6-8 John Street and 13B Church Avenue,
Mascot

Response to Request for Information (DA/2019/385)

On behalf of
Iglu No. 211 Pty Ltd
April 2020

Figure 3. Proposed covered temporary holding bay (highlighted in blue) on the Lower Ground Plan (DA03.0G1)

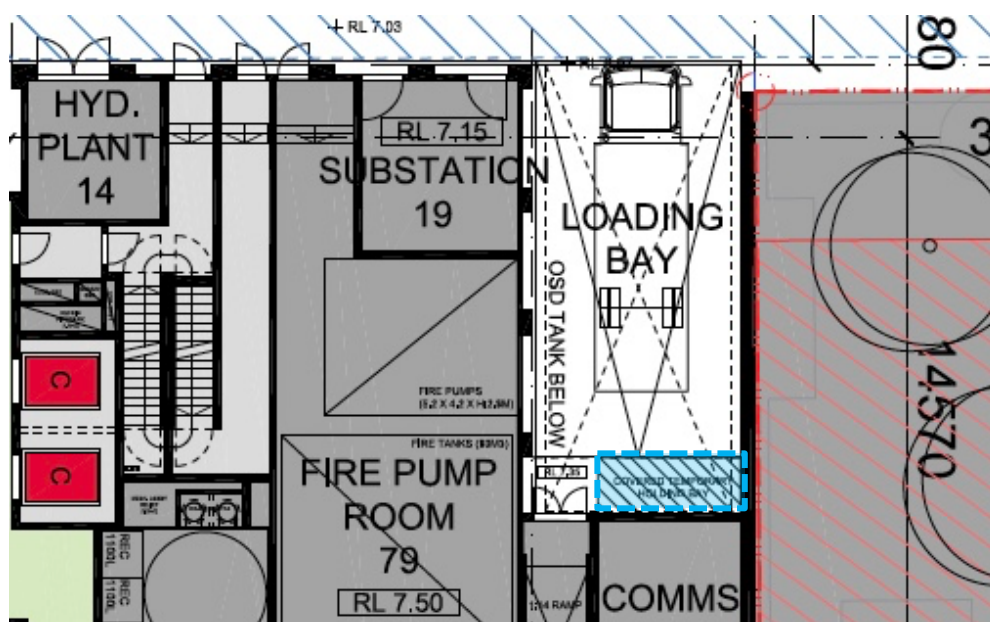
Firstly, the location of the loading dock at the rear of the site is in close proximity to the residential units and communal open space of the adjoining developments at 13A Church Avenue and 10-14 John Street. How will the noise be managed? Is there a solid wall/materials proposed between the sites to mitigate the noise that comes from garbage collection? What type of management plan is in force to address this? There are hours proposed in the acoustic report which restrict garbage collection and loading/unloading to certain hours. Please confirm these are the hours are proposed.

- **Loading Dock:** Council accepted the location of the Loading dock in the meeting on Tuesday 10 March 2020. The revised architectural plans have included the provision of a temporary covered external holding bay for loading/unloading of goods and to provide protection for workers.
- In accordance with the updated *Acoustic Report* in **Attachment 7**, the loading dock shall only operate between the following hours;
 - 7am – 10pm Monday to Saturday, or
 - 8am to 10pm Sunday or public holidays.
- Trucks within the loading dock shall ensure that engines and refrigeration units are turned off while located within the dock area apart from when entering and departing the dock area.

Figure 5. Roof Section (Version D, Page 23 of 37)
Source: RPS

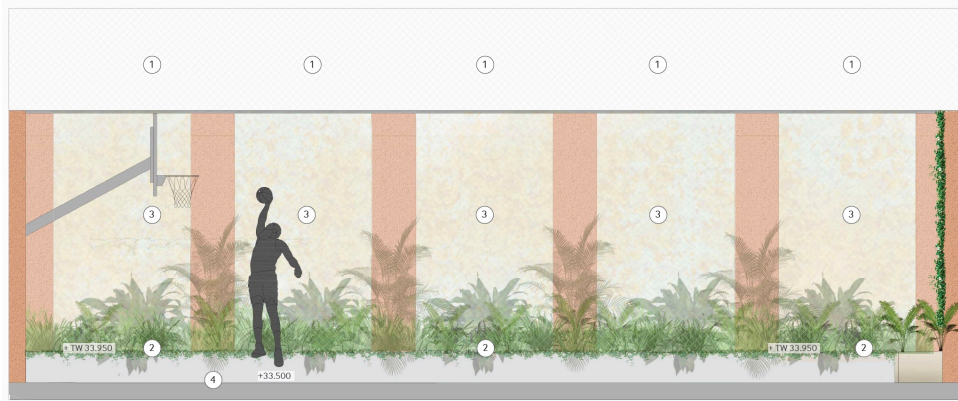
Thirdly, it is not clear how the basketball court on the rooftop of the rear building has been enclosed. The plans show that there is an enclosure of some sort however is this roofed? Also is this enclosure transparent fencing or solid wall? Are there time restrictions proposed for the use of the basketball court particularly as it is located adjacent to residential units. It seems like an assessment of the potential noise from this area has not been considered within the acoustic report by acoustic logic.

Page 23 of 37 of the revised *Landscape Plans* illustrate the proposed structure enclosing the basketball court. The enclosure will comprise of a transparent mesh structure in between the pillars and a mesh canopy. This will provide a structure for plants to grow on, provide safety for its users and confine basketballs to the designated court. For further detail on the enclosure structure, refer the updated Architectural Plans in **Attachment 1**.

Further mitigation measures to manage the acoustic emissions, a 3.6m high solid sound barrier wall will be installed on north façade of the basketball court (only). This sound barrier will be comprised of clear toughened glass, Perspex, wood, metal materials or the likes. The plans also include the installation of 1m high solid balustrade/ planter-boxes to east and south of the court.

Figure 7. WC facilities provided on Lower Ground Level (DA03.0G1, Rev B)

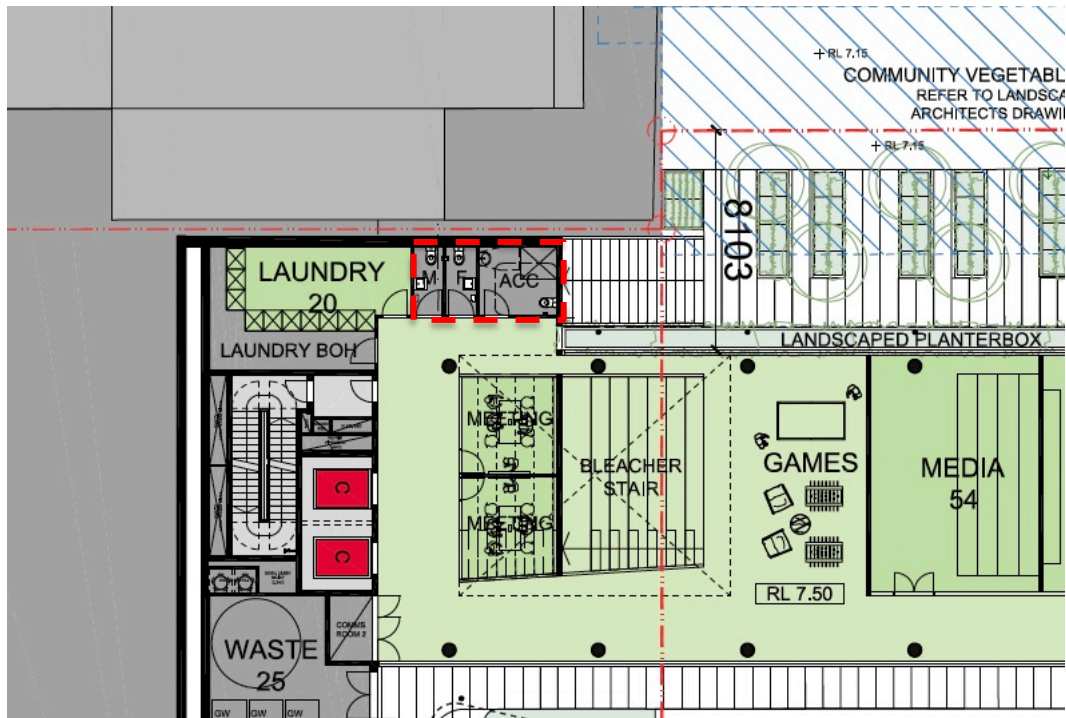
2.6.1 Common bathroom located adjacent to the lounge and café area would benefit from the students and any visitors and staff having to go up to the rooms or to the lower level to use these facilities.

The cafe provided within the development is not a commercial cafe but rather a 'Grab and Go' Breakfast Bar for use by students only. Common bathroom facilities are located on Lower Ground adjacent to the immediate entry core. In response to Council's comment, further detail has been added to the accessible WC, including shower. Refer to the updated Architectural Plans in **Attachment 1**.

Figure 9. Revised Landscape treatment to the western facade of the communal rooftop on John Street (Page 21 of 37, Version D)
Source: RPS

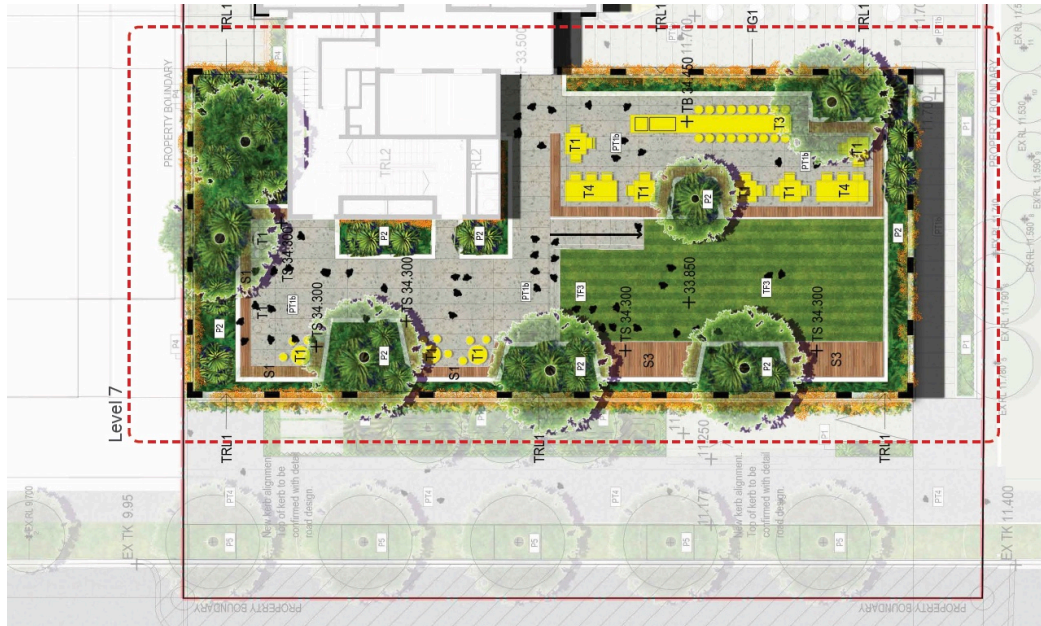
Setback along the western side of communal rooftop area on front building facing John Street can benefit in having a larger setback off the side boundary to avoid noise and visual privacy issues. Should you consider not increasing the terrace being setback away from the boundary, a greater landscape planter bed area should be incorporated within the development.

The lodged DA included a wrap-around landscaped planter-box zone around the entire south roof terrace. As illustrated on Page 21 of the revised *Landscape Plans (Attachment 6)*, the communal rooftop has been revised to allow for a greater landscape planter along the western side of the communal rooftop. These plans continue to provide extensive planting, including vertical planting on the facade trellis, providing an acoustic and visual buffer from the neighbours.

Figure 10. Revised Architectural Plans – Gym glazing on Lower Ground Floor Plan (DA03.0G1, Rev B).
Source: Bates Smart

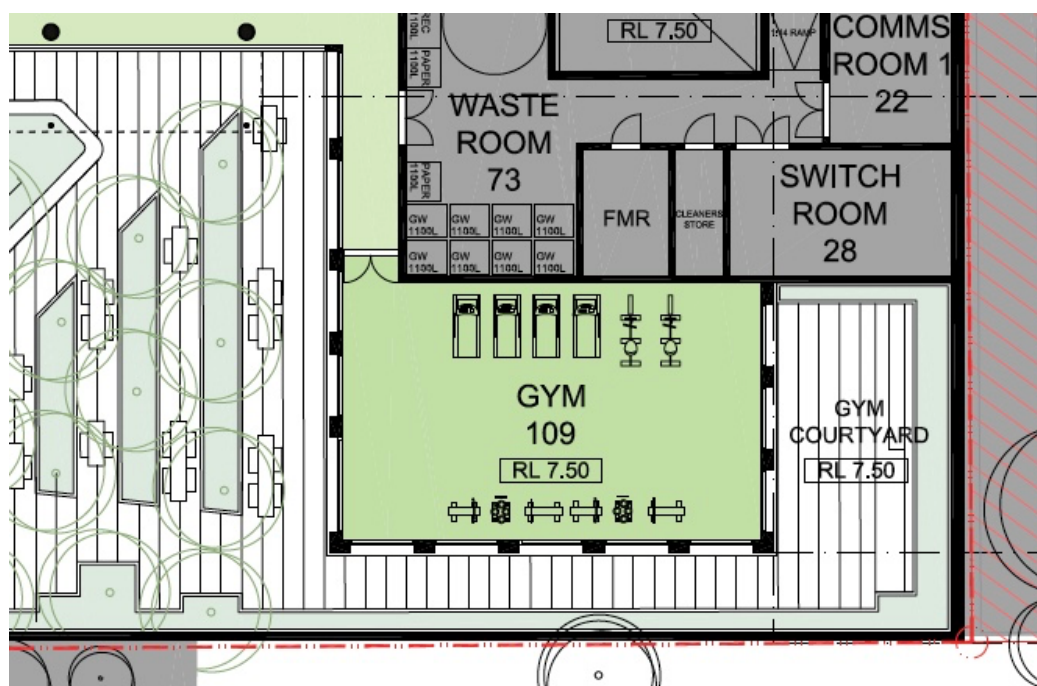
2.6.12 Is the gym at the lower level enclosed by walls or is open? It is not very clear on the plans.

The gym on the lower level is open on three sides, with glazing between perimeter facade columns that continue down to ground level. The plans have been updated to provide more clarity. Refer to the Revised Architectural Plan DA03.0G1 in **Attachment 2**.

Figure 11. Location of Waste Rooms (highlighted in blue) and path of travel on Lower Ground Floor Plan (DA03.0G1, Rev B).

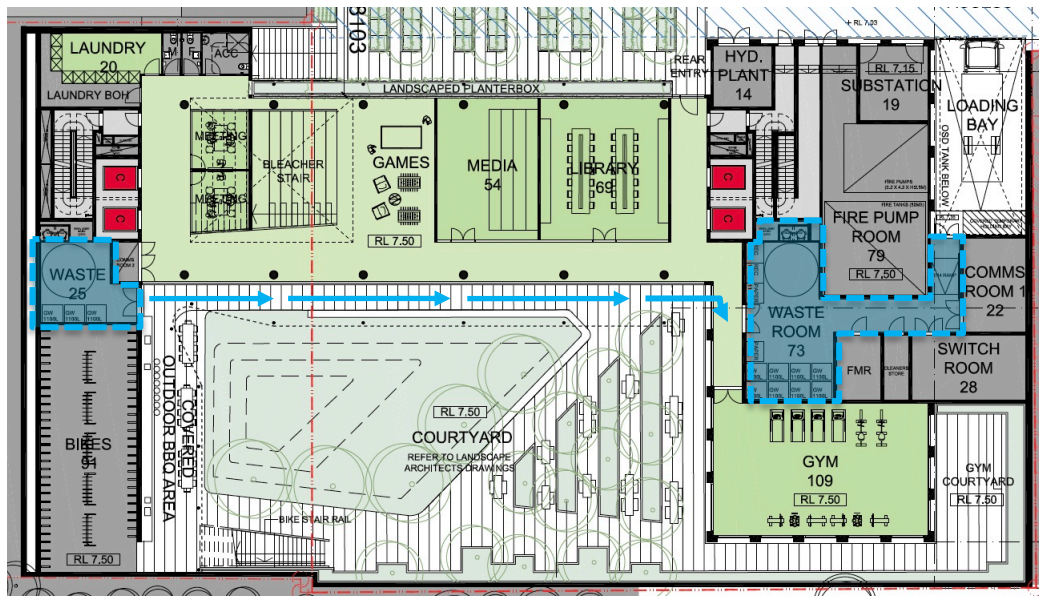
2.6.13 The waste room is proposed on the southern portion of the lower ground level. This should be reconfigured to be directly adjoining the loading dock. At this stage, how is the waste located in this waste room transported to the loading dock? Through the communal open space area?

The development comprises two (2) waste rooms as there are waste chutes in both cores to service all rooms. The northern waste room is considered the primary waste room due to the servicing of more rooms and proximity to the loading dock, and therefore has an increased size and holding capacity. The waste is relocated from the south to north waste room by building management

and contract cleaners via the paved walkway in the lower ground courtyard which is undercover and setback extensively from the east and west boundaries.
